DATE: November 5, 2019
TO: Blue Bird Owners
Subject: RECALL R18ZO, Blue Bird Vision Alternator Cable Routing with Ford Engine

SUBJECT: RECALL R18ZO, Blue Bird Vision Alternator Cable Routing with Ford Engine

Alternator Cable Routing Vision With Ford Engine

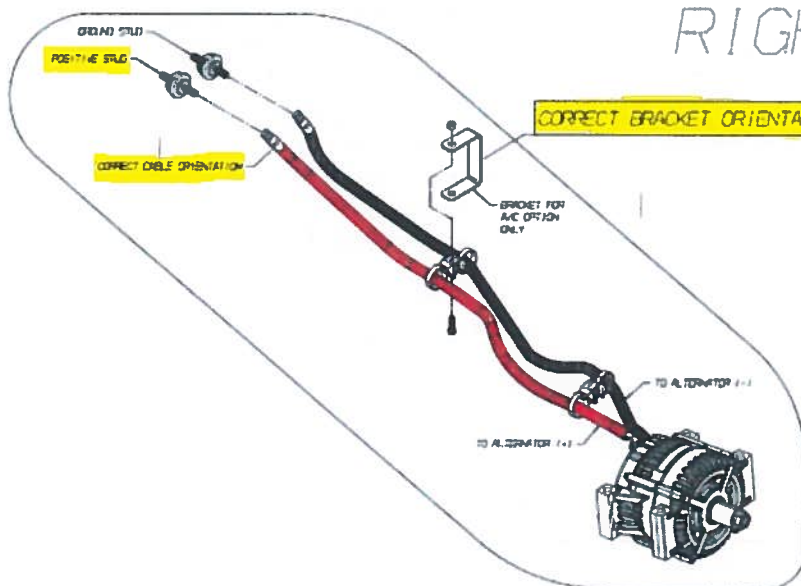
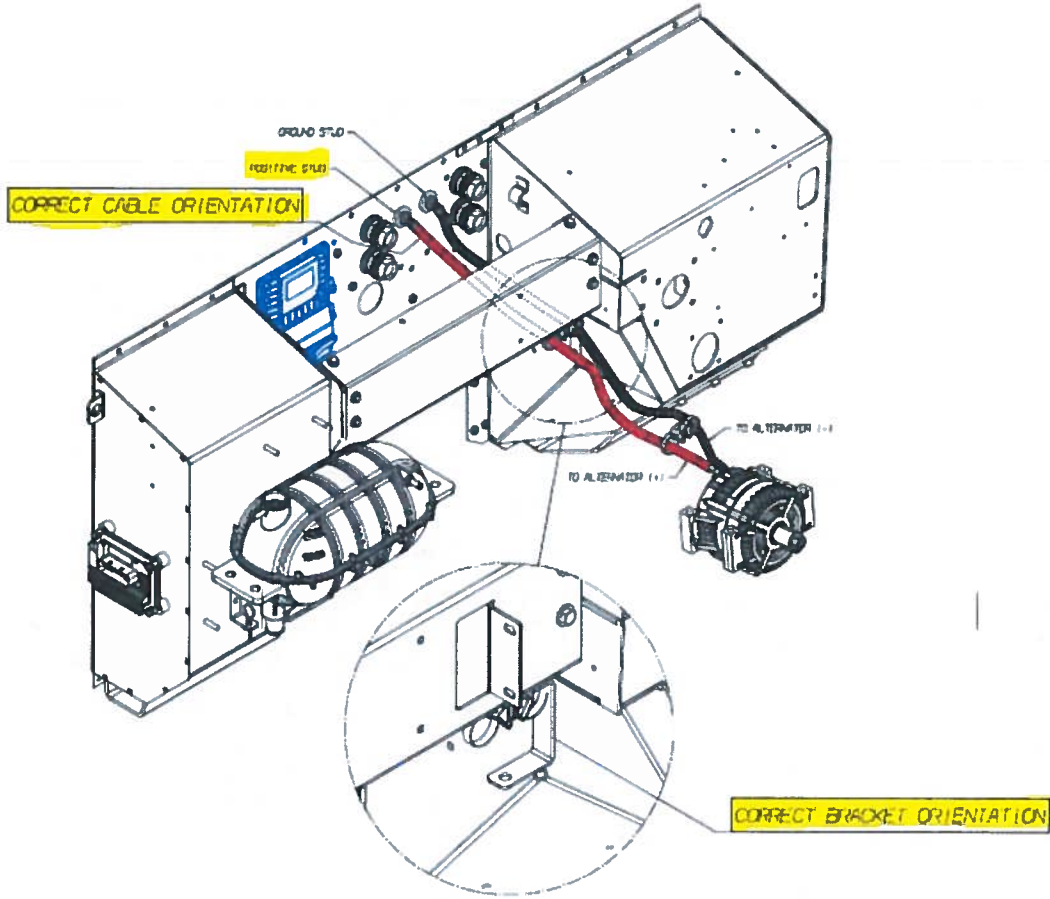
5. If alternator cable orientation on positive stud requires correction, loosen the stud nut, reorient cable per “RIGHT WAY” illustration Page 2, and torque stud nut to 11-15 ft. lbs.

6. If bracket for A/C option orientation requires correction, loosen the attaching nut, reorient bracket per “RIGHT WAY” illustration Page 2, and torque attaching nut to 5-7 ft. lbs.
7. If reorientation in either step 5 or step 6 was required, inspect for any possible damage to the alternator cable. **If any damage is present, contact your local Blue Bird Dealer for replacement alternator cable.**
8. Reconnect batteries by connecting the negative cable last. Return bus to service.
